Access Compliance Report

Public Rights-of-Way

(Curb Ramps)

Intersection ID: 17675	Main Street: DONEGAL_DR	Cross Street: RAMA_RD	Location: E
ADA ID: 75BF8F7721A2	Ramp Type: PerpDiag	Initial Pass/Fail: Fail	Overall Compliance: No
Severity Score: 37.5			
Codes/Mitigation Info/Possible Solution		Field Measurements/Component Compliance

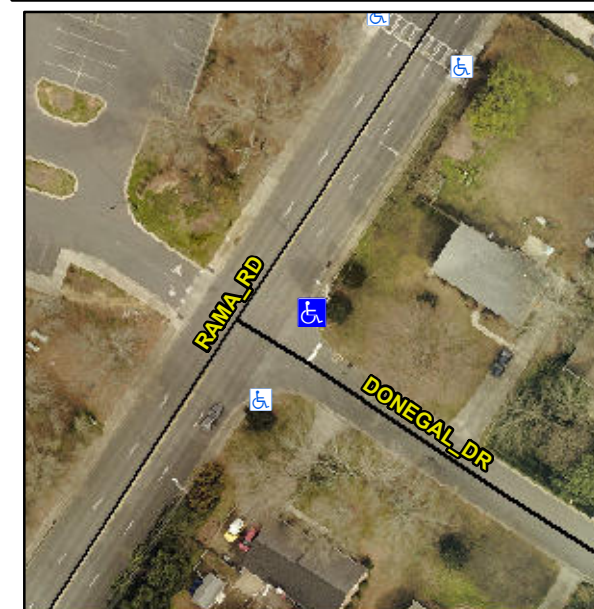
Not Found, R304.2.2, R304.5.3

Compliance	Description	Data	Compliance	Description	Data
N/A	Ramp Length (in)	54.0	No	Ramp Slope (%)	8.7
Yes	Ramp Width (in)	48.0	No	Ramp XSlope (%)	10.7
N/A	Flare Type LT	N/A	N/A	Flare Type RT	N/A
N/A	Flare Slope LT (%)	N/A	N/A	Flare Slope RT (%)	N/A
N/A	Flare Traversable LT?	N/A	N/A	Flare Traversable RT?	N/A
N/A	Landing Length (in)	N/A	N/A	DWS Provided?	N/A
N/A	Landing Width (in)	N/A	N/A	DWS Contrast?	N/A
N/A	Landing Slope (%)	N/A	N/A	DWS Length (in)	N/A
N/A	Landing X Slope (%)	N/A	N/A	DWS Full Width?	N/A
N/A	Landing Curb? (Y/N)	N/A	N/A	DWS Offset (in)	N/A
N/A	Shared Landing?	N/A			
N/A	Gutter Ponding?	N/A	N/A	Gutter Slope (%)	N/A
N/A	Gutter Lip Ht (in)	N/A	N/A	Gutter X Slope (%)	N/A
N/A	Painted X Walk1?	No	N/A	Painted X Walk2?	No
	X Walk 1 Direction	To NW		X Walk 2 Direction	To SW
N/A	X Walk 1 Width (in)	N/A	N/A	X Walk 2 Width (in)	N/A
	X Walk 1 Slope (%)	8.3		X Walk 2 Slope (%)	1.9
	X Walk 1 X Slope (%)	3.7		X Walk 2 X Slope (%)	9.1

N/A	Ramp inside XWalk1?	N/A	N/A	Ramp inside XWalk2?	N/A
	Road Slope (%)	8.7	N/A	Clear Space?	N/A
	Road X Slope (%)	4.8	N/A	Clear Space to XWalk (in)	N/A
N/A	Any Obstructions?	N/A	N/A	Storm Grate/Utility Hazard?	N/A
	Obstruction Type			Storm Grate/Utility Type	
		N/A			N/A
		Yes		Surface Condition? (G/P)	Good

Remove & Replace Curb Ramp With Two New Directional Ramps or Equivalent.
